Status of Radiation Protection studies in support of ELENA

R. Froeschl and J. Vollaire
DGS-RP-AS

List of RP studies for ELENA / AD

Preliminary conclusions ELENA shielding

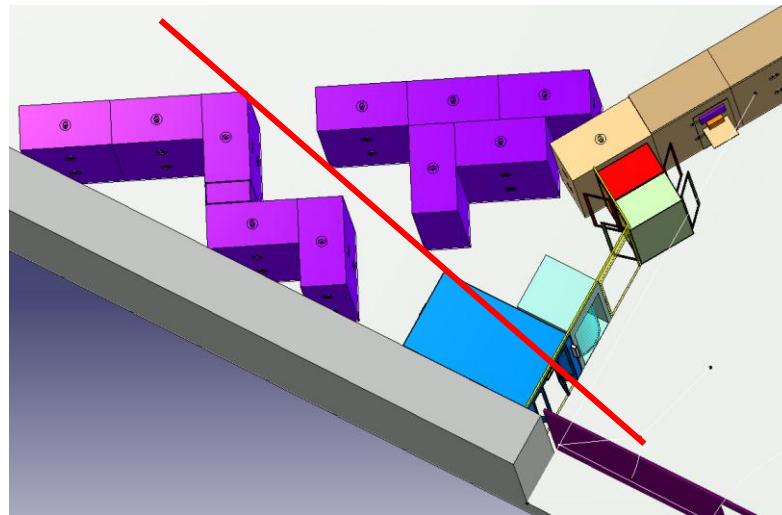
- ▶ Shielding thickness compatible with AD hall classification
- ▶ Location of the platform (visitors) to be properly chosen to ensure minimum exposure (it has to be moved away from the shielding enclosure)
- ▶ Concrete blocks implementation must ensure 80 cm of shielding (connection of slanted walls....)
